STELL PARTS & S	Incorrect Gear		ical Service Bulle Indicator Conso Stitching Colo	le And Ar	mrest Console	
REFERENCE:	TSB : 23-045-23 GROUP 23 - Body	Date:	April 19, 2023	REVISION:	-	
VEHICLES AFFECTED:	2022 (WD) Dodge Durango This bulletin applies to vehicles built on November 29, 2022 (MDH 1129XX) equipped with Orange Accent Stitching (Sales Code MTN) and Suede Wrapped Interior Accents (Sales Code XDA).		MARKET AF	PLICABILITY: CH IAP MEA		
CUSTOMER SYMPTOM:	Gear shift indicator console, bezel and armrest console is wrong color.					
CAUSE:	Incorrect stitching on center console.

Fig. 1 Correct Color Stitching (ORANGE)

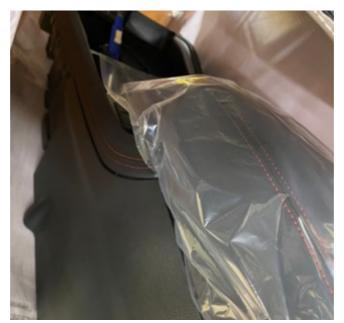
1. Does the vehicle have orange color stitching on the console? (Fig. 1), (Fig. 2)?

- YES>>> This bulletin does not apply. Use Inspect LOP (21-75-15-92) to close this active RSU.
- NO>>> Proceed to Step 2.
- Replace the center console and bezel. Refer to the detailed service procedures listed in DealerCONNECT> Service Library under: 23 - Body / Interior / Console, Floor / Removal and installation and 23 - Body / Interior / Bezel, Shifter / Removal/ and Installation.
